**Item 3.****Development Application: 22-32 Botany Road, Alexandria - D/2021/292**

File No.: D/2021/292

Figure 32: Section drawing demonstrating height breach

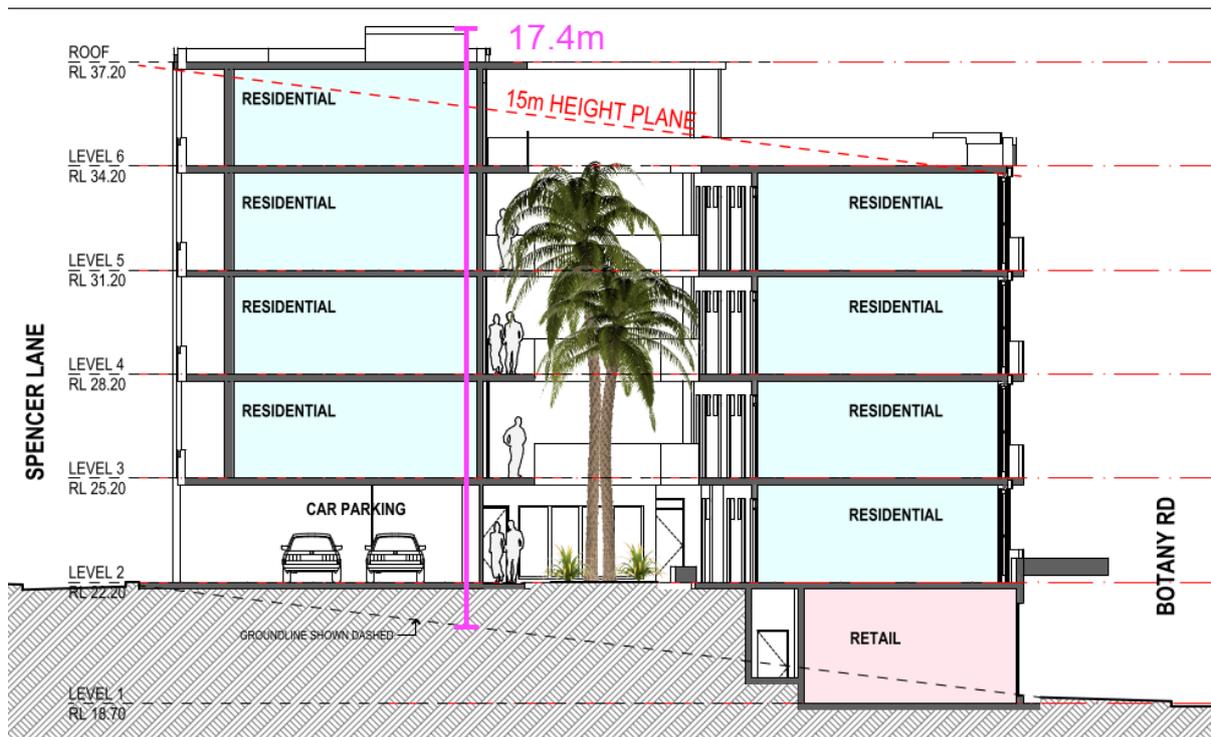
57. The site is subject to a maximum height control of 15m. The section and elevation drawings below detail the maximum height of the new development, which is to the top of the lift overrun. The section has not been drawn through the tallest part of the building. Depending on which drawing used to measure the maximum height of the development, the height breach ranges between 17.4m and 18.2m, which comprises between a 16% and 21.3% variation to the height standard.

- The site is subject to a 15m height in metres control and a 4 storey height of buildings control. The proposal exceeds both controls. The submitted Clause 4.6 variation request identifies a maximum variation of 2.4m (for an overall height of 17.4m of 16%) however the section drawing from which the measurement is taken is not through the tallest portion of the development. Consequently, the information provided is insufficient to accurately determine the precise variation. The assessment of Council officers (refer to Figure 33 above) illustrates a height breach of up to 3.2m or a 21.3% exceedance of the height standard, taken from the top of the lift overrun. Consequently the 4.6 variation request is not considered to be accurate and is not supported.

- The portion of the development exceeding the height standard includes part of the fifth storey to Spencer Lane (which houses 6 boarding house rooms and the rooftop indoor communal area), the pergola to the outdoor communal area, the parapet of the communal area at the east (Botany Road) side of the rooftop space, the lift overrun, and the southern set of fire stairs and adjacent plant room. These elements of the development could easily be accommodated within the maximum height plane through the removal of a single storey. This would result in a development where the majority of the uppermost storey would comply with the height standard, with the added benefit that the current floor space ratio exceedance would also be reduced. This is a far more preferable and acceptable planning and urban design outcome.
